P.R.D. DEVELOPMENT STANDARDS FOR:

PARKSIDE

APRIL 28, 1994 MAY 16, 1994 (Redline Corrections)

RE: PLANNING COMMISSION APPROVAL OF P-94-10, Z-94-14 (PARKSIDE)

PROPOSED PRELIMINARY PLAT

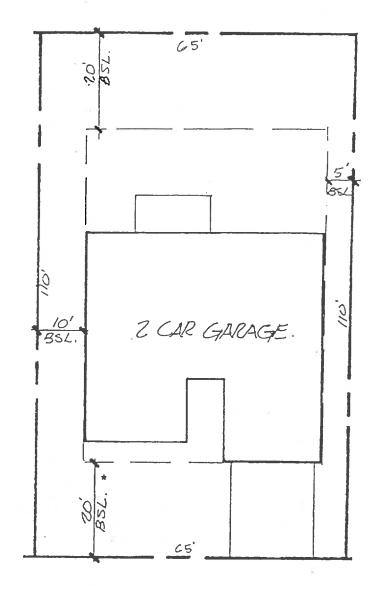
- 3. The alignment of 83rd Lane and the configuration of Lot 78 shall be modified as necessary to eliminate concerns regarding site distance visibility.

- 4. The sewer easement on Lot 60 shall be repositioned west of Lot 60 within Tract A.
- 5. The developer shall pay an in-lieu fee, in an amount which will compensate the City for the future subdivision sewer maintenance, as approved by the City Engineer.
